## **OAKSTONE SUBDIVISION**

APPLICATION NUMBER 8 DATE September 6, 2012

REQUEST Subdivision

## DETAIL SITE PLAN

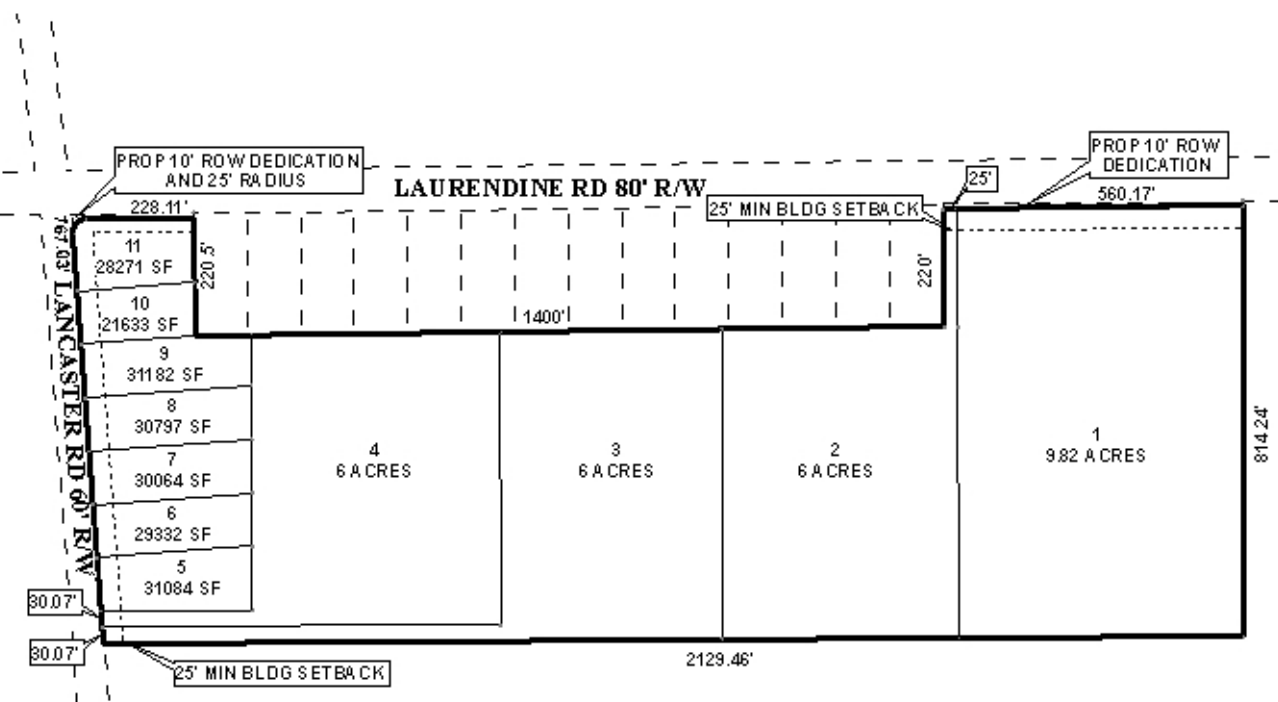
The site fronts Lancaster Road and Laurendine Road. Lancaster Road is a minor street; the existing right-of-way meets the minimum width standards for minor streets. Laurendine Road, with an existing right-of-way of 80 feet, is a proposed major street, and as such, its right-of-way should be 100-feet according to the Major Street Plan. Therefore, the dedication of an additional 10-feet, (50-feet from the centerline of Laurendine Road) which is depicted on the preliminary plat, should be required along the site's Laurendine Road frontage as well as sufficient radius at the intersection of Lancaster Road and Laurendine Road, with the approval of Mobile County Engineering and in conformance to AASHTO standards.

As Laurendine Road is a proposed major street, access management is a concern. The subdivision, as currently designed, depicts lots 1, 2 and 11 as having frontage on Laurendine Road. Lot 11 also fronts Lancaster Road, thus it should be restricted to having access only onto Lancaster Road in order to prevent an additional curb cut onto Laurendine Road, due to its designation as a Major Street. Due to their frontage on Laurendine Road; lots 1 and 2 should be

allowed a total of three curb cuts to Laurendine Road with both lots sharing a common curb cut at their common property line and lot 1 should be allowed two separate curb cuts onto Laurendine Road, with the size, design, and location of all proposed curb cuts onto Laurendine Road, to be approved by the Mobile County Engineering Department and conform to AASHTO standards. Lots 3-10 provide frontage along Lancaster Road; therefore, each lot should be limited to one curb cut each to Lancaster Road, with the size, design and location, be approved by Mobile County Engineering and conform to AASHTO standards.

The preliminary plat illustrates all lots except Lot 11 road frontage on Laurendine Road as 40-feet. The minimum building setback as referenced in Section V.D.9. of the Subdivision Regulations of the Subdivision Regulations is 25-feet. It should be noted that the setback line on all flag lots should be illustrated on the Final Plat from the end of the pole.

Lots 1 and 5-11 far exceed the 15,000 square feet required by Section V.D.2. of the Subdivision Regulations for individual septic systems. Lots 2-4 are flag-shaped lots with 25-foot road frontage; however, it would be appropriate to waive Section V.D.1. of the Subdivision Regulations, due to several subdivisions within the immediate area have been approved with flag-shaped lots.

The eastern portion of the site appears to be within the FEMA designated "100-year" floodplain of Muddy Creek, and wetlands associated with the creek may occur on a portion of the site. The presence of wetlands and floodplains indicate that the area may be environmentally sensitive; therefore, the approval of all applicable federal, state and local agencies would be required prior to the issuance of any permits or commencement of any land disturbing. It should also be noted that detention ponds cannot be located within the 100-year floodplain; therefore, the applicant should consult the Mobile County Engineering staff to ensure that the detention pond is appropriately located.

With a waiver of Section V.D.1, the preliminary plat meets the minimum requirements of the Subdivision Regulations and is recommended for Tentative Approval subject to the following conditions:

- 1) dedication of sufficient right-of-way to provide 50-feet from the centerline of Laurendine Road;
- 2) dedication of sufficient right-of-way radius at the southeast quadrant of the Laurendine Road/Lancaster Road intersection, with the size and design to be approved by County Engineering and conform to AASHTO standards;

- 6) the placement of a note on the Final Plat stating that Lots 1 and 2 be allowed a total of three curb cuts to Laurendine Road with one being a shared common curb cut at the interior property line of the two lots, with the size, design and location to be approved by Mobile County Engineering Department and conform to AASHTO standards;

- 7) the placement of a note on the Final Plat stating that Lot 11, is denied access to Laurendine Road and limited to one curb cut to Lancaster Road, with the size, design and location to be approved by County Engineering and conform to AASHTO standards;

- 8) the placement of a note on the Final Plat stating Lots 3-10 are allowed one curb cut each to Lancaster Road, with the size, design and location to be approved by Mobile County Engineering and conform to AASHTO standards;
